DEVELOPMENT
APPLICATION

DRAWING REGISTER

OUR LADY OF THE ROSARY
CATHOLIC SCHOOL
The Entrance

PROJECT NAME :
**OUR LADY OF THE ROSARY
CATHOLIC SCHOOL**

ELEVATIONS NORTH

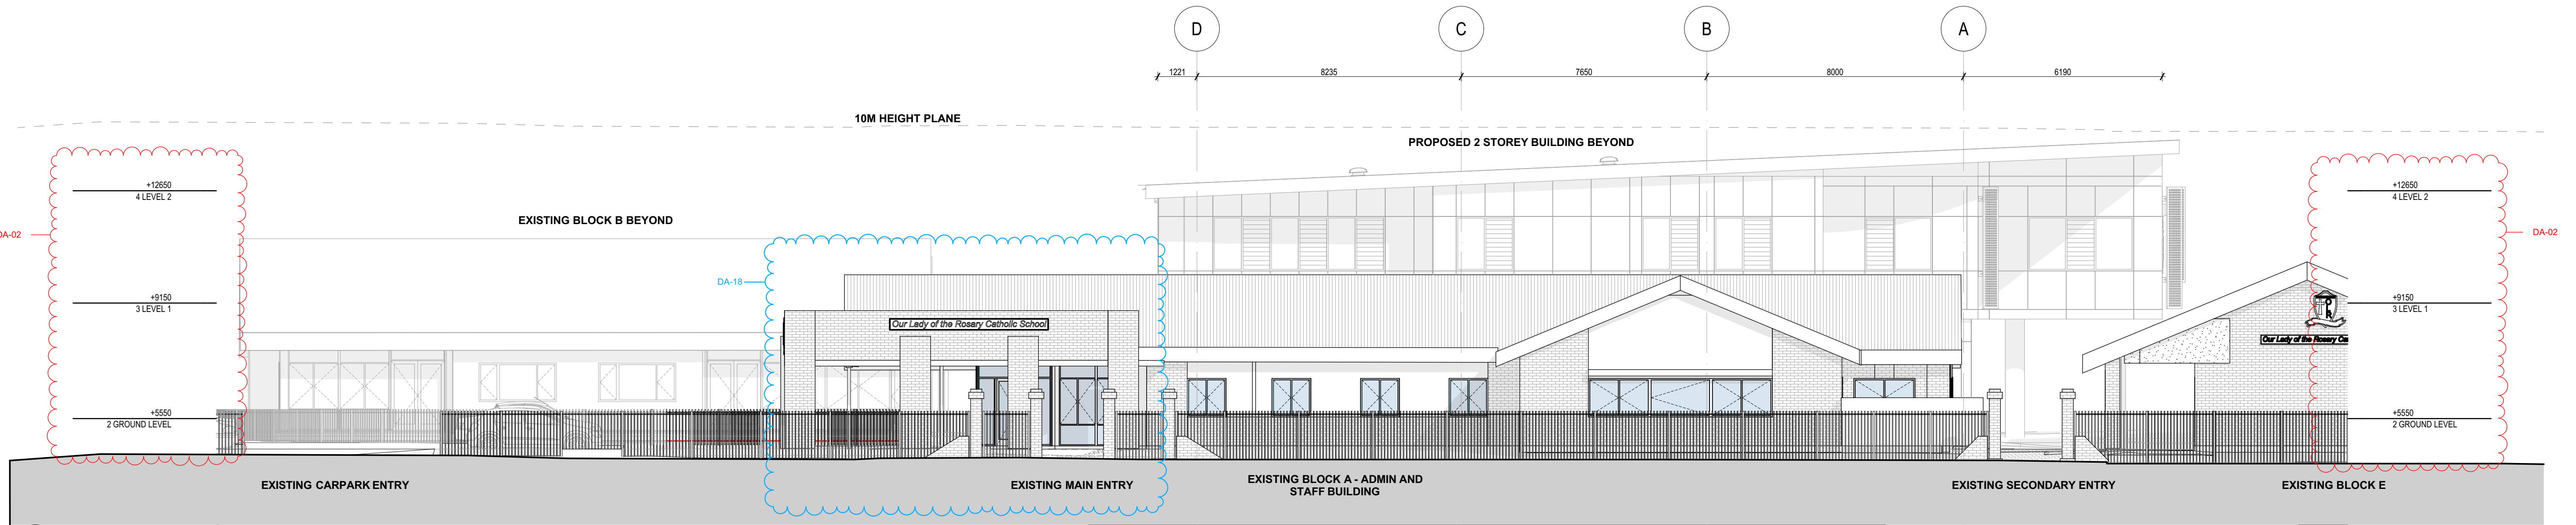
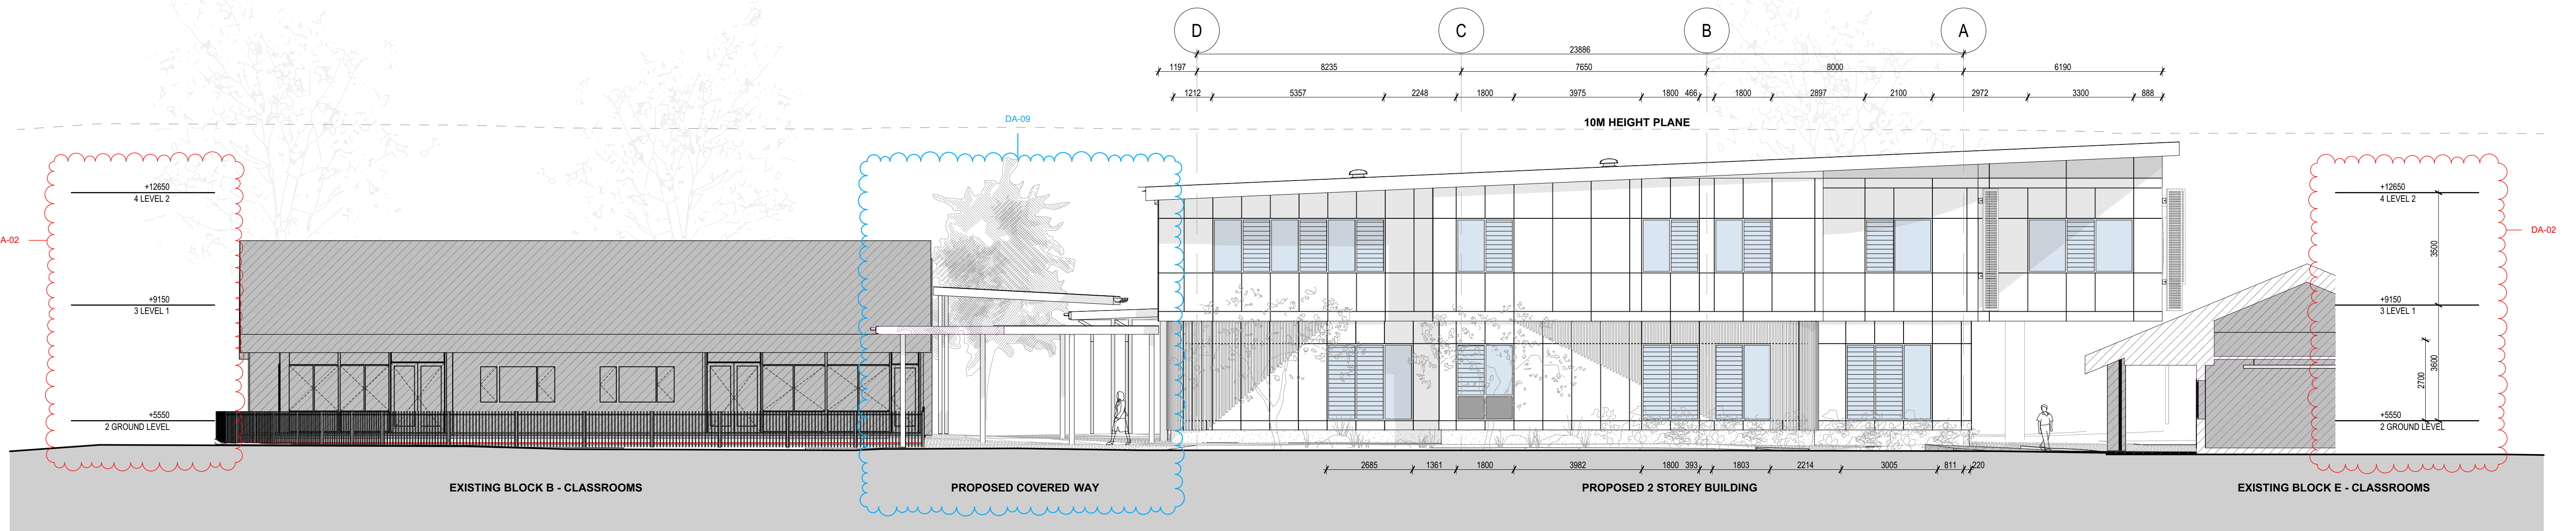
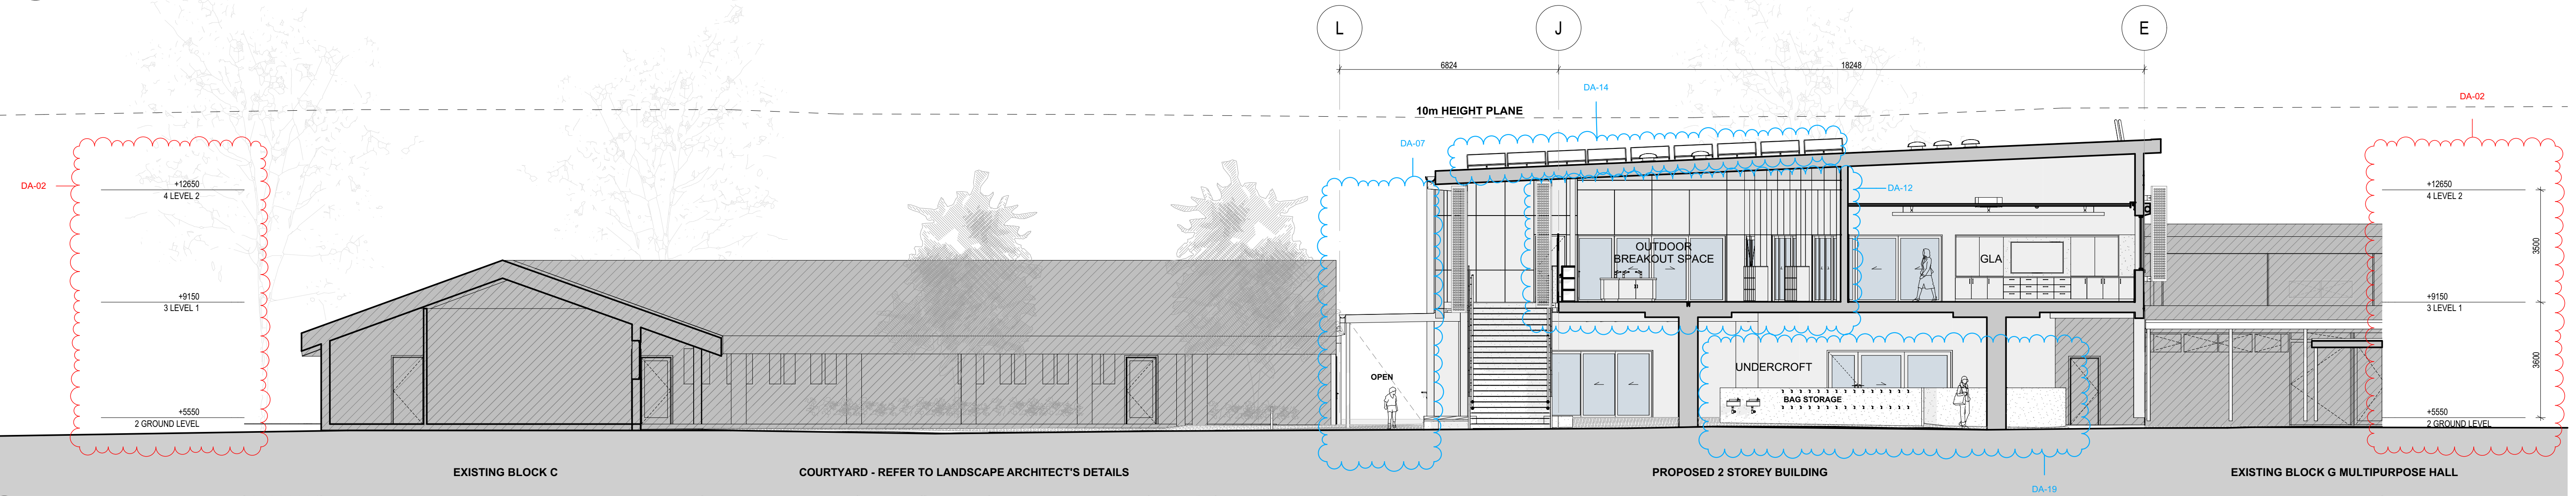
DA-19	UNDERCROFT LEVELS ADJUSTED TO SUIT NEW FFL
DA-18	EXISTING BUILDING ENTRY FACADE UPGRADE REMOVED FROM SCOPE
DA-14	SOLAR PANELS ADDED TO ROOF
DA-12	GLA'S RECONFIGURED AROUND EXTERNALISED SHARED SPACE
DA-09	ENTRY CANOPY REDUCED IN SIZE
DA-07	BLOCK H WALL MOVED AWAY FROM BLOCK C
DA-02	FFL RAISED TO SUIT FLOOD LEVEL

DRAWING TITLE :
ELEVATIONS
ELEVATIONS EAST

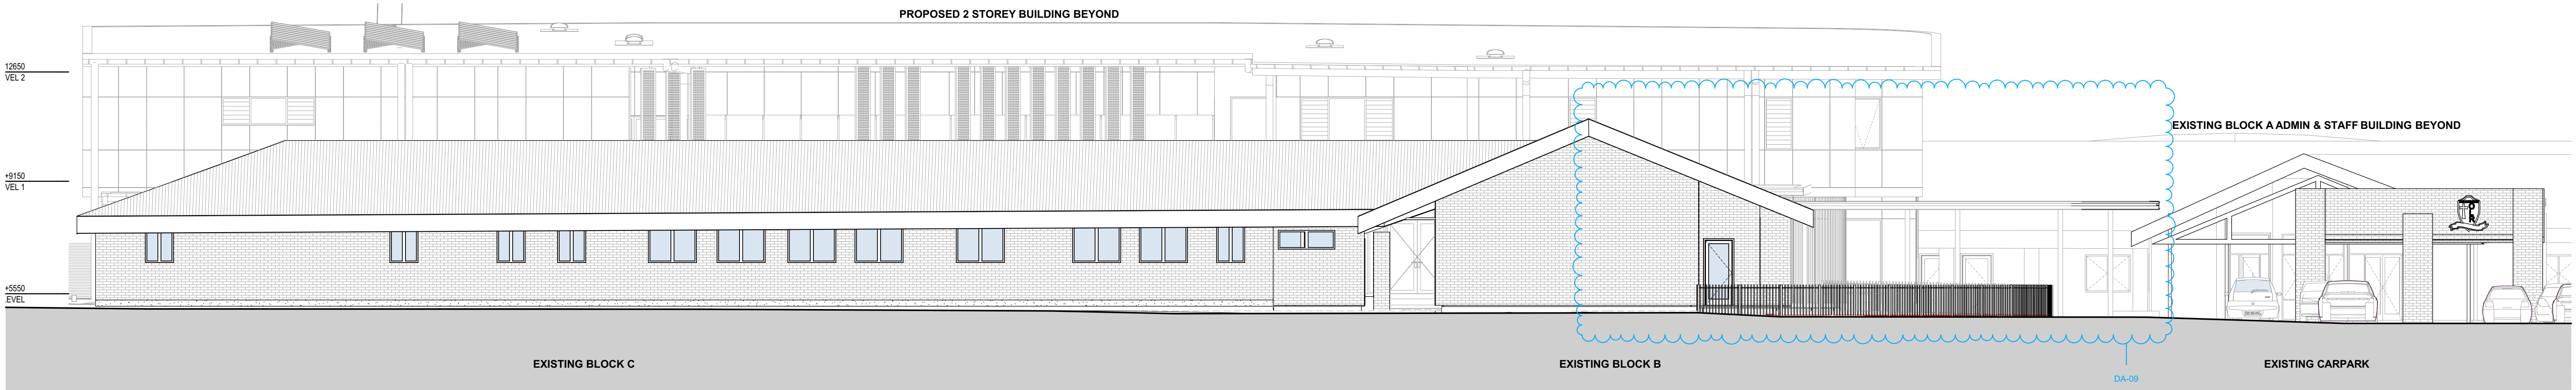
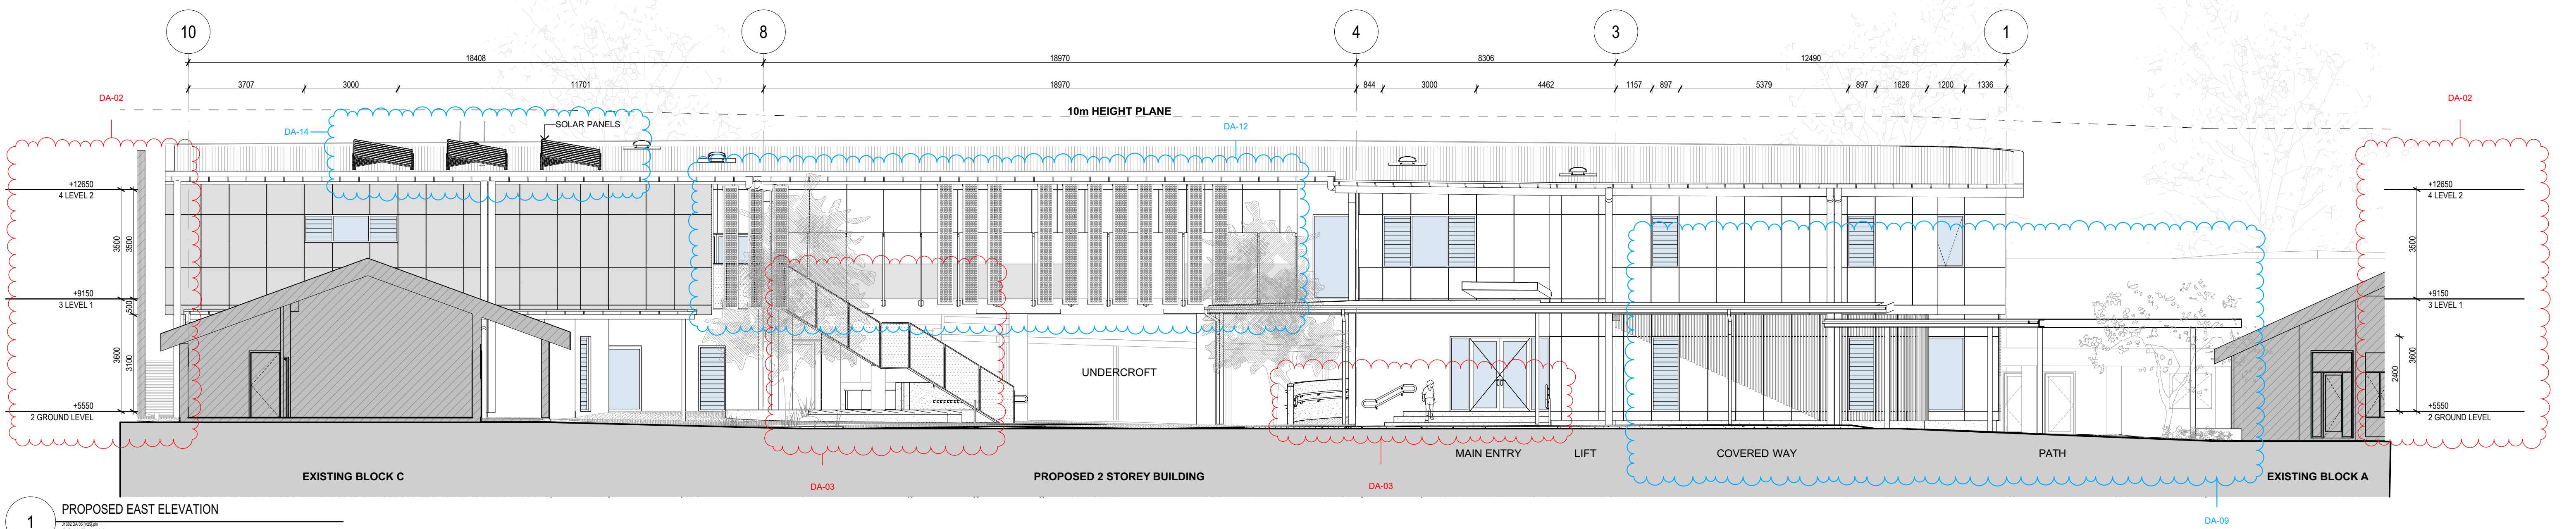
REVISION CHANGE REGISTER	
DA-14	SOLAR PANELS ADDED TO ROOF
DA-12	GLA'S RECONFIGURED AROUND EXTERNALISED SHARED SPACE
DA-09	ENTRY CANOPY REDUCED IN SIZE
DA-03	STAIRS AND RAMP ADJUSTED TO SUIT NEW FFL
DA-02	FFL RAISED TO SUIT FLOOD LEVEL
